WEST BOUNTIFUL PLANNING COMMISSION

THE WEST BOUNTIFUL PLANNING COMMISSION WILL HOLD A MEETING BEGINNING AT 7:30 PM ON TUESDAY, JANUARY 9, 2018 AT THE CITY OFFICES

RE: High Gate Subdivision Final Plat

HIGH GATE ESTATES SUBDIVISION

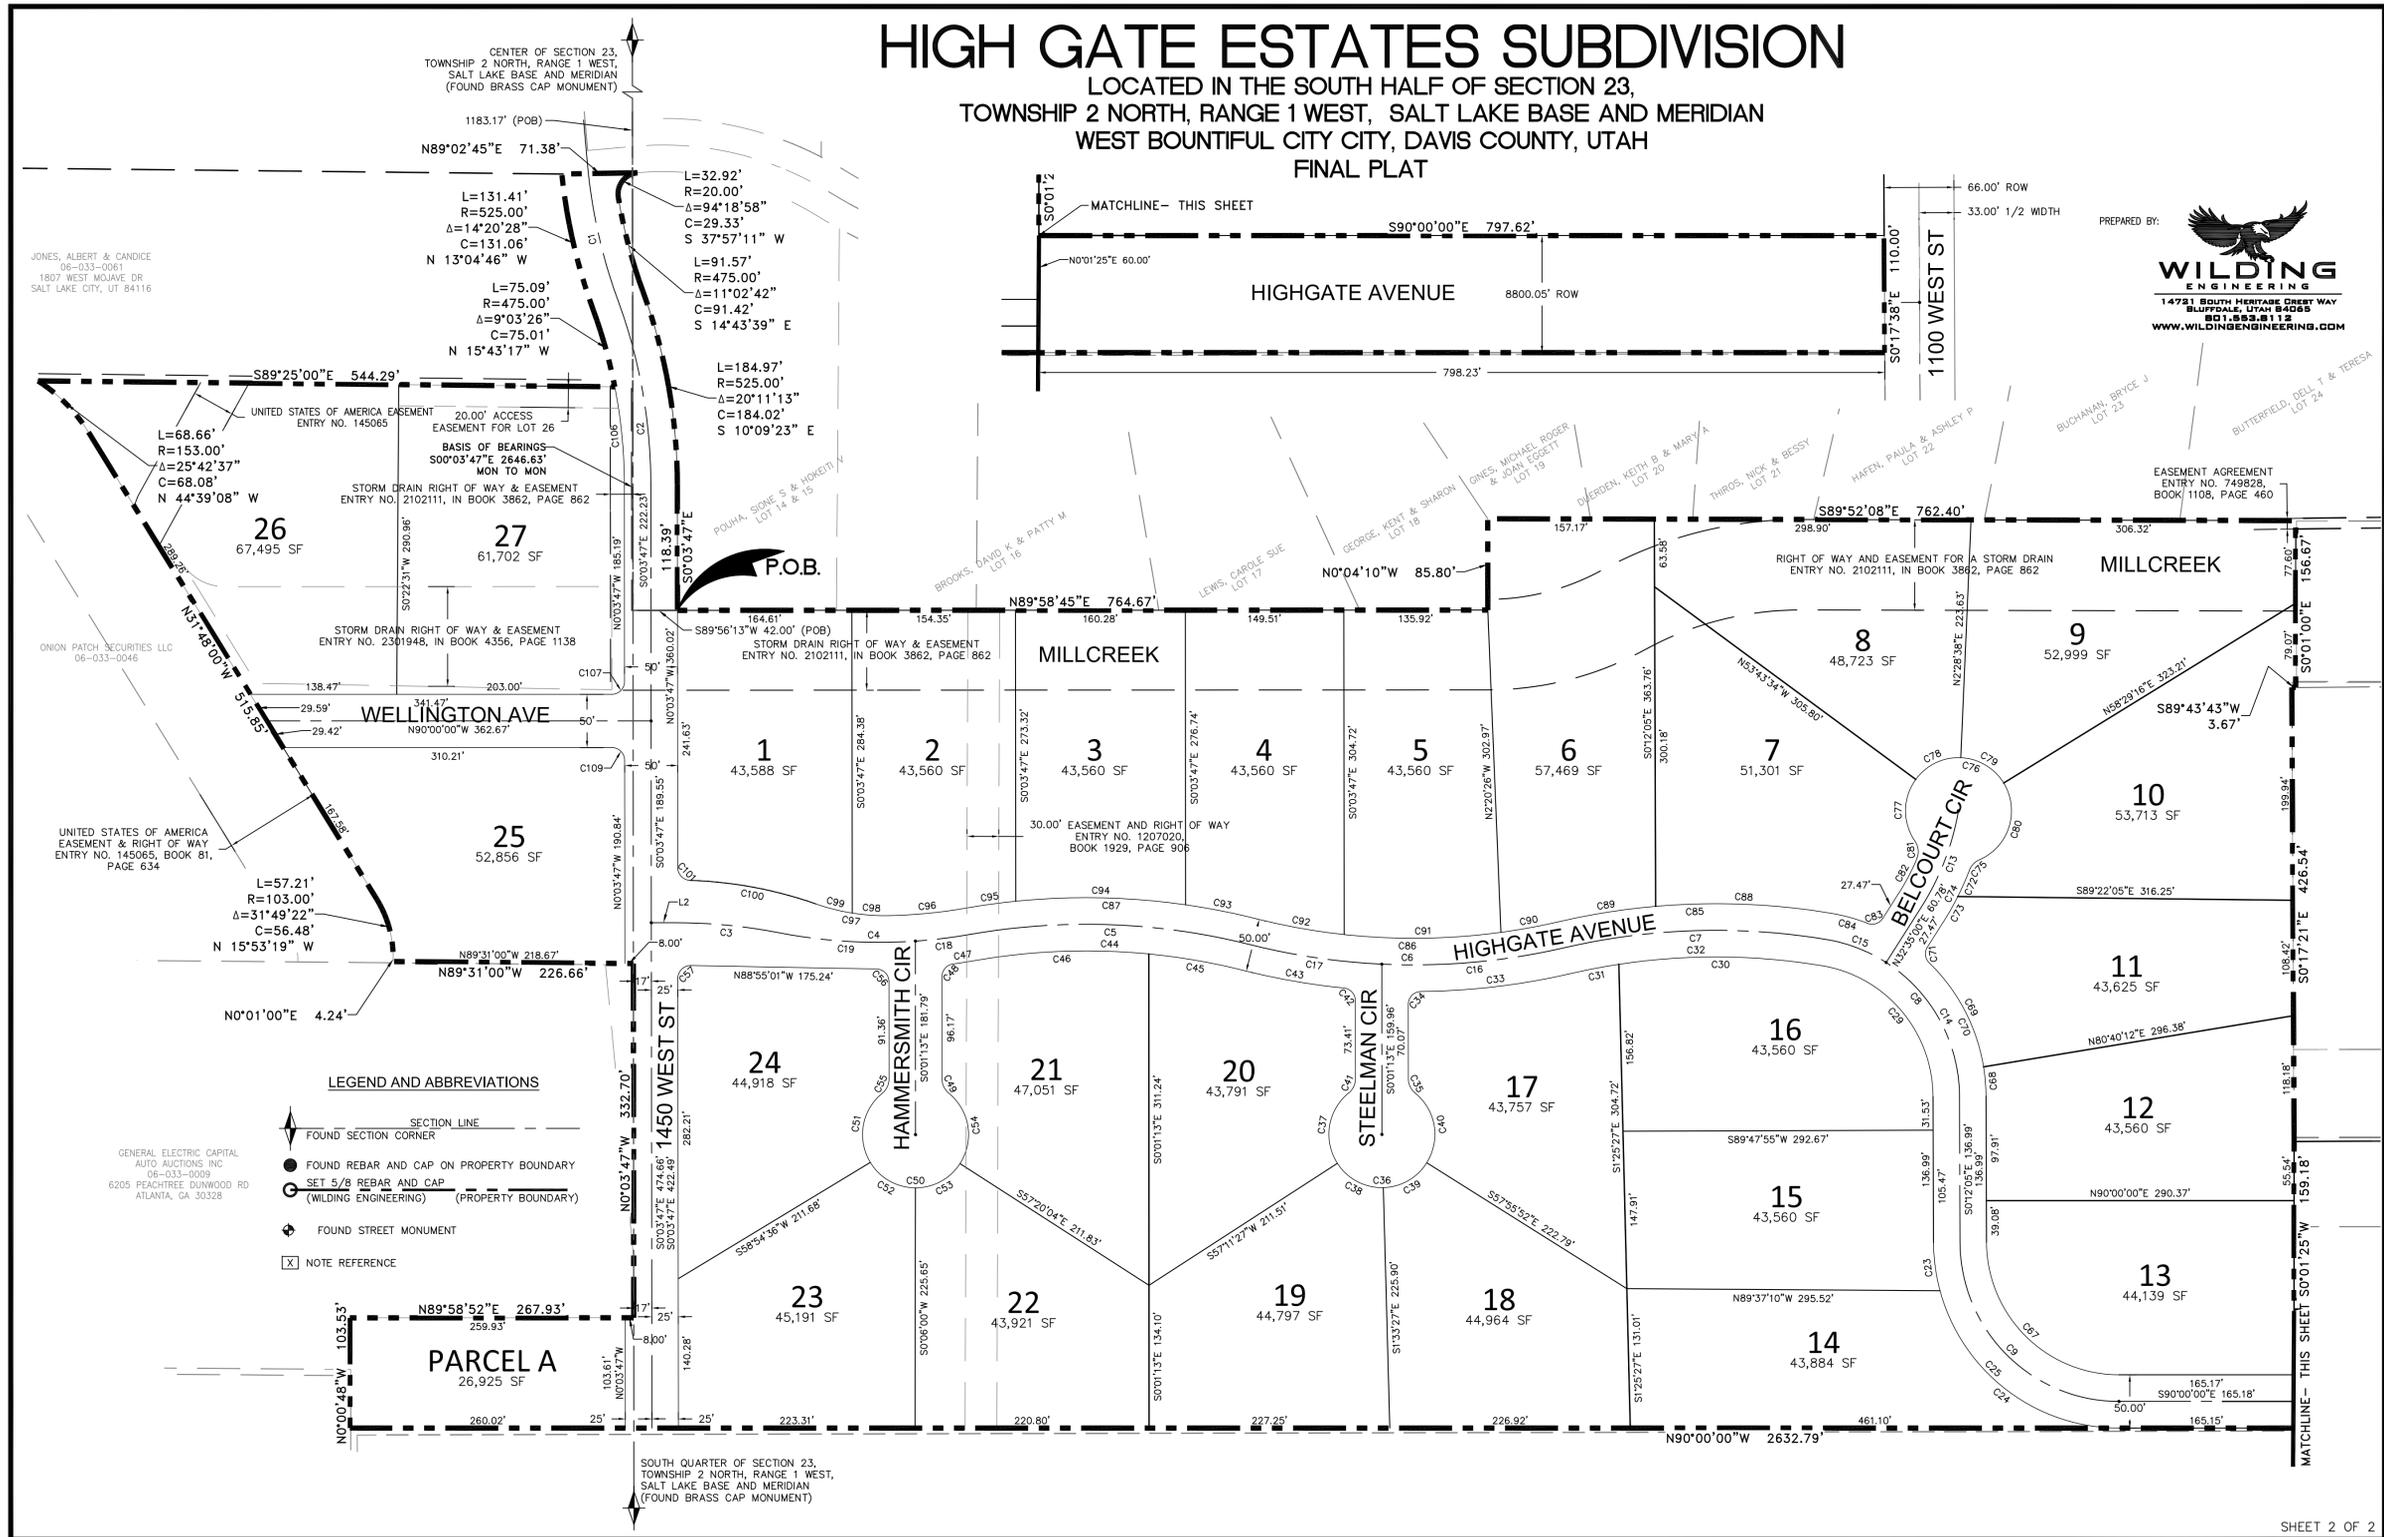
3. Davis County has agreed to allow a direct discharge into the canal in return for other contributions by the developer. As of the time of this memo, public works has not had the opportunity to comment on the proposal that the storm drain run between lots 1 and 2 before discharging into the canal. Staff would also like to eliminate the detention basin near lot 13 and pipe that water straight to the canal.

4. The Developer owns a large parcel of land west of this development. The Sewer District has agreed to construct the sewer line to the west and the property owner has agreed to grant the easement. This sewer line will eliminate the need for a sewer lift station.

5. 1450 West is included to extend south to the development boundary with a temporary vehicle turnaround. There is a 0.5 acre parcel at the south end of the road that is approved for commercial use only (not residential). It is in the B-U zone and not the A-1 zone.

6. A Holly Frontier wastewater drain line cuts through the property. The Sewer District will be intercepting and rerouting the flow in 1100 West. The result is that the line through the development will either be abandoned in place or the pipeline removed.

7. A remnant parcel of ground is property off 1450 North against Mill Creek Meadows. The developer is working with the adjoining property owner for its sale. If it is not sold to the adjoining property owner prior to plat recording, it will be become street right of way and the responsibility of the H.O.A. to maintain.

8. Jack Williams owns the property to the south of the development. He has expressed a desire for street access. As proposed, the development will provide access to the Williams property at the west end (1450 W) and at the east end of Lot 14 where the right of way aligns with the south property boundary.
9. A portion of the Mill Creek channel is located within this development. The Developer owns the ground and Davis County has an easement. As the plat is currently drawn, Mill Creek is included within the lots. A fence will be maintained between the Mill Creek channel and the home owners' rear yards.

- A. West Avenue will be renamed.
- B. Provide a title report with no objectionable entries;
- C. Payment of fees and storm water impact fee;
- D. Post the appropriate improvement bonds;
- E. Execute an Improvement Agreement with the City;
- F. Execute a Development Agreement which includes the landscape maintenance requirements;
- G. Deed water right to City or payment in kind;
- H. Final design approval by utility companies and Bureau of Reclamation for a storm drain discharge;
- I. Minor clarifications on engineering drawings.
